DART AEROSPACE LTD	Work Order: 125055
Description: Crosstube Assembly	Part Number: D407-667-145
Inspection Dwg: D407-667-145 Rev: C	Page 1 of 2

DESIGN	9	DART AEROSPACE LTD HAWKESBURY, ONTARIO, CANADA	
DRAWN	RF		
CHECKED	9	DRAWING NO. D407-667-145	REV. C SHEET 4 OF 4
MFG. APPR.	9	TITLE CROSSTUBE ASSY (407 HIGH FWD)	SCALE NTS
APPROVED	9	COPYRIGHT © 2002 BY DART AEROSPACE LTD THIS DOCUMENT IS PRIVATE AND CONFIDENTIAL AND IS SUPPLIED ON THE EXPRESS CONDITION THAT IT IS NOT TO BE USED FOR ANY PURPOSES OR COMMUNICATED TO ANY OTHER PERSON WITHOUT WRITTEN PERMISSION FROM DART AEROSPACE LTD.	
DE APPR.	9		
DATE	08.11.06

DRAWING NO. D407-667-145	TITLE CROSSTUBE ASS'Y (407 HIGH FWD)	REV. C	DART AEROSPACE LTD ENGINEERING ORDER		D.E.O. NO. D407-667-145-C-1	SHEET NO. SHEET 1 OF 1	SCALE NTS
DRAWN <i>90</i>	CHECKED <i>ASS</i>	MFG. APPR. <i>IB</i>	APPROVED <i>WD</i>		DE APPR. <i>HA</i>		
DATE 11.07.15	DATE 11.07.22	DATE 11.07.22	DATE 11/07/22		DATE 11.07.21

DRAWING NO. D407-667-145	TITLE CROSSTUBE ASS'Y (407 HIGH FWD)	REV. C	DART AEROSPACE LTD ENGINEERING ORDER	D.E.O. NO. D407-667-145-C-2	SHEET NO. SHEET 1 OF 1	SCALE NTS
DRAWN AJS	CHECKED [Signature]	MFG. APPR. [Signature]	APPROVED [Signature]	DE

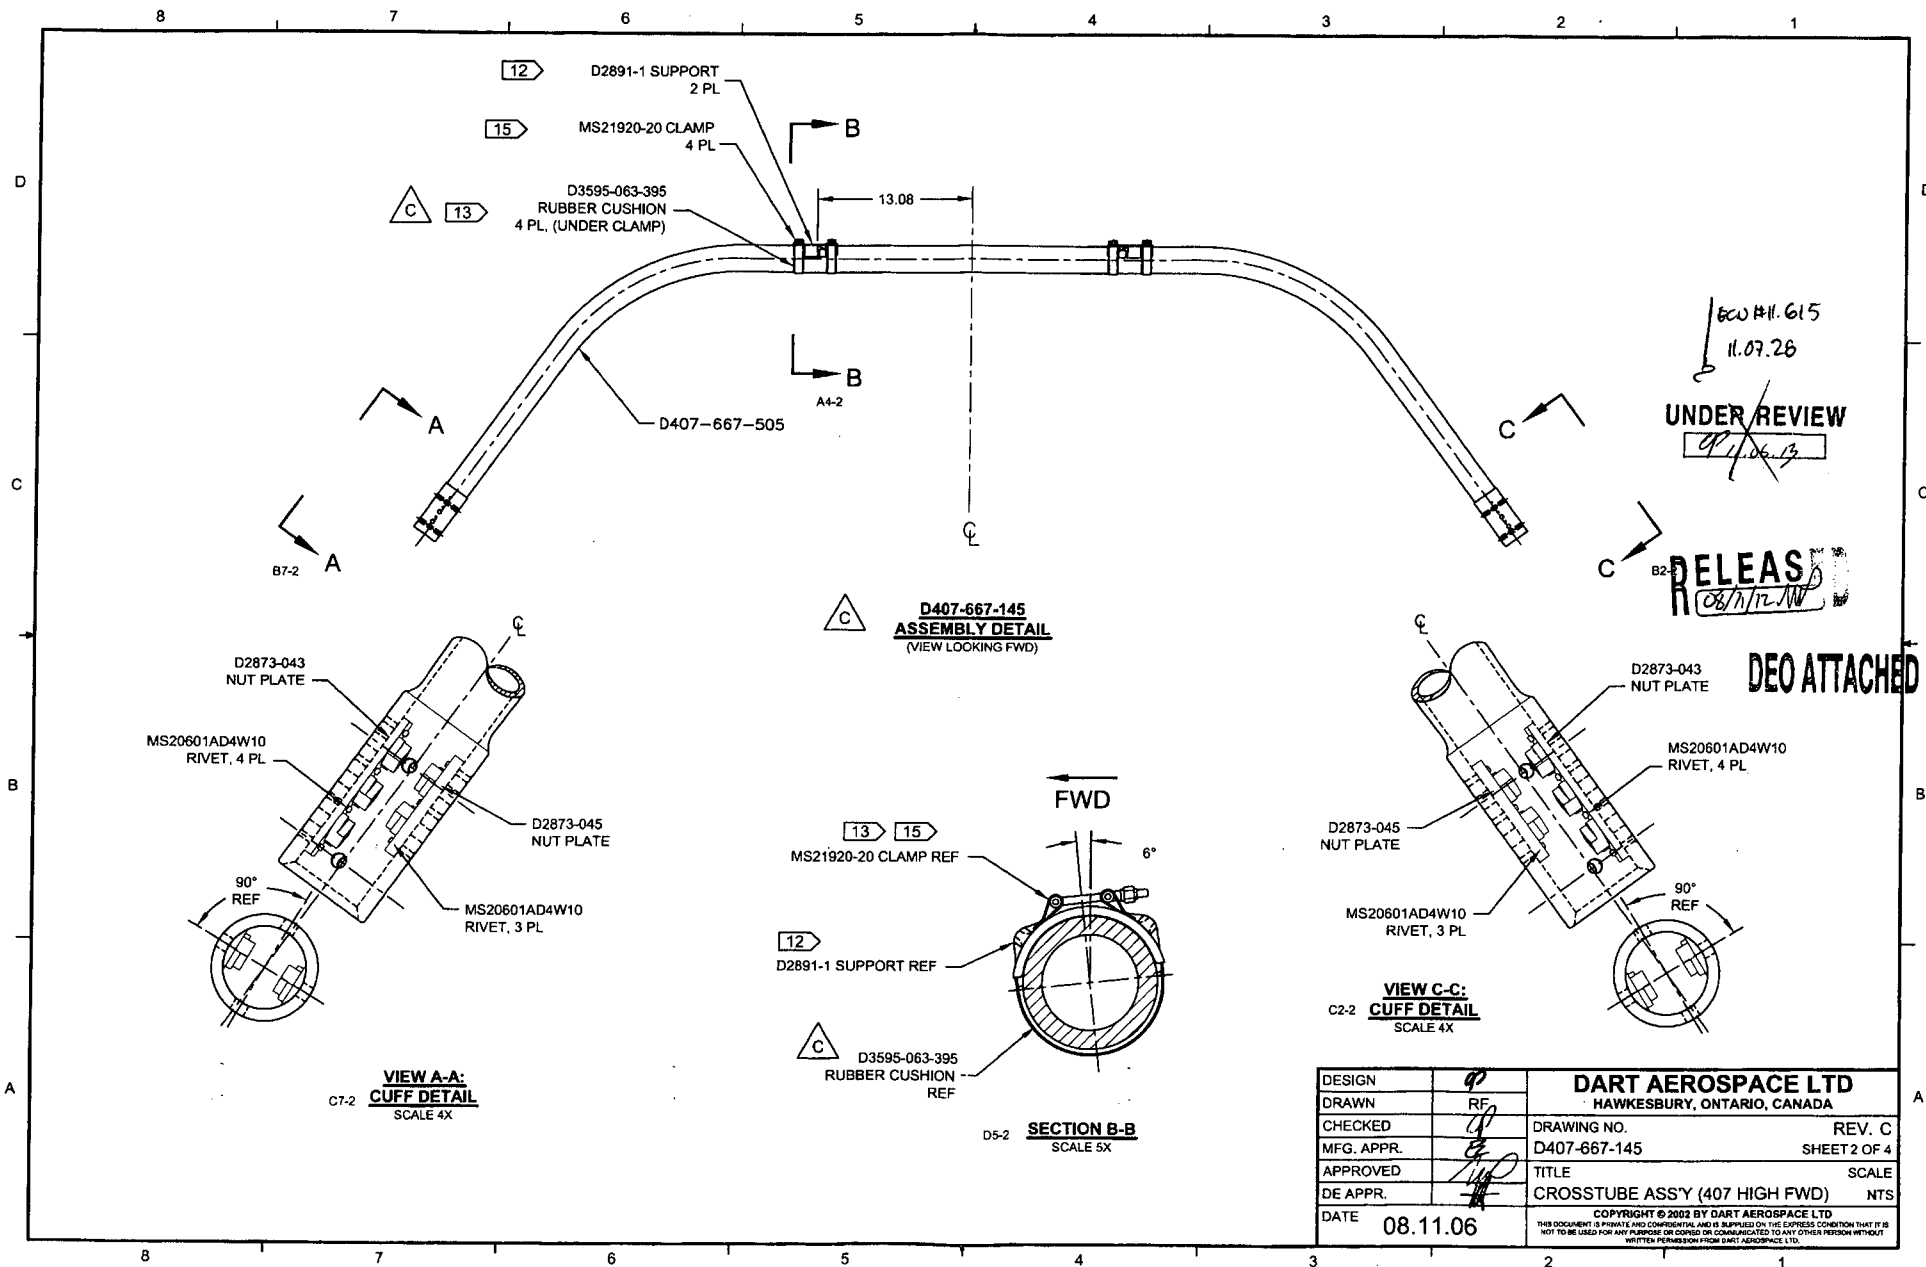
C	REVISE GENERAL NOTES/PART LIST (ZN D7-1); REORGANIZED VIEWS AND REFORMATTED DRAWING TO CURRENT STANDARDS. D3595-063-395 WAS D2856-400-694 (ZN D8-2 & A5-2); REMOVED REF. 7 ADD TOLERANCES (ZN C8-3, C4-3, D2-3); RELOCATED FLAG #6 (ZN A8-3) PER NCR 210; MOVED TURNING DETAIL & UPDATED TOLERANCE TO SHEET 4.	RF	08.11.06
B	ADD HOLES AND NUT PLATES FOR COMPATABILITY WITH BHT/AA SKUDTUBES	PH	05.07.26
A	NEW ISSUE	CP	02.05.08
REV.	DESCRIPTION	BY	DATE
DESIGN	RF	DART AEROSPACE LTD HAWKESBURY, ONTARIO, CANADA	
DRAWN	RF	DRAWING NO. D407-667-145	REV. C SHEET 1 OF 4
CHECKED	RF	TITLE CROSSTUBE ASSY (407 HIGH FWD)	SCALE NTS
MFG. APPR.	RF	COPYRIGHT © 2002 BY DART AEROSPACE LTD THIS DOCUMENT IS PRIVATE AND CONFIDENTIAL AND IS SUPPLIED ON THE EXPRESS CONDITION THAT IT IS NOT TO BE USED FOR ANY PURPOSE OR FOR CONSTRUCTION TO ANY OTHER PERSON WITHOUT WRITTEN PERMISSION FROM DART AEROSPACE LTD.	
APPROVED	RF	DATE 08.11.06

DETAIL P
BONDING STRAP INSTALLATION 2 PL

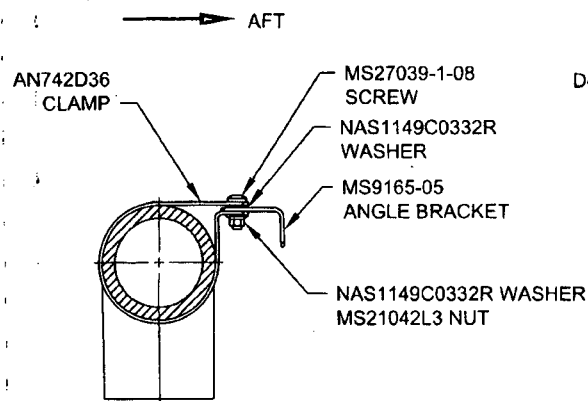
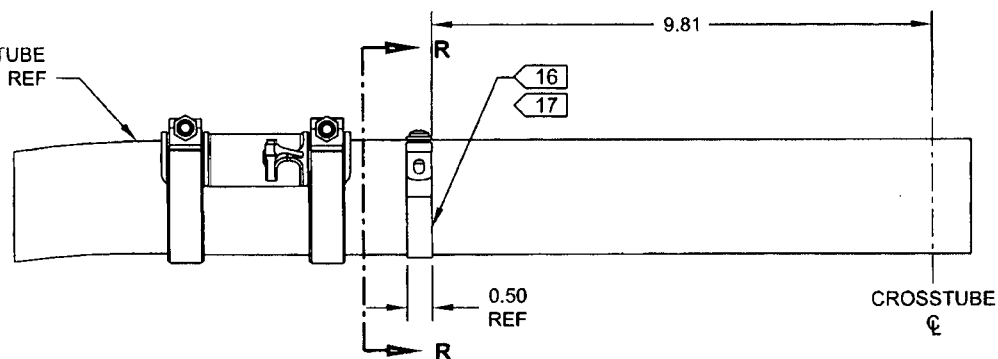
PURPOSE:

ADD ELECTRICAL GROUNDING STRAP

CHANGE:

ITEM	QTY -145	PART NUMBER	DESCRIPTION
1	X	D407-667-145	CROSSTUBE ASSEMBLY (407 HIGH FWD)
10	2	AN742D36	CLAMP
11	2	MS9165-05	ANGLE BRACKET
12	2	MS21042L3	NUT (OR MS21042-3)
13	2	MS27039-1-08	SCREW
14	4	NAS1149C0332R	WASHER (OR AN960C10L)

- 16) MASK AREA UNDER CLAMP PRIOR TO PAINTING
- 17) SEAL EDGES WHERE AN742D36 CLAMP MEETS WITH THE CROSSTUBE USING SIKAFLEX-241/-291 OR MIL-S-8802 CLASS B2 OR PROSEAL 890 SEALANT
- 18) PERFORM RESISTANCE CHECK TO ENSURE MAX RESISTANCE IS 10 MILLIOHMS
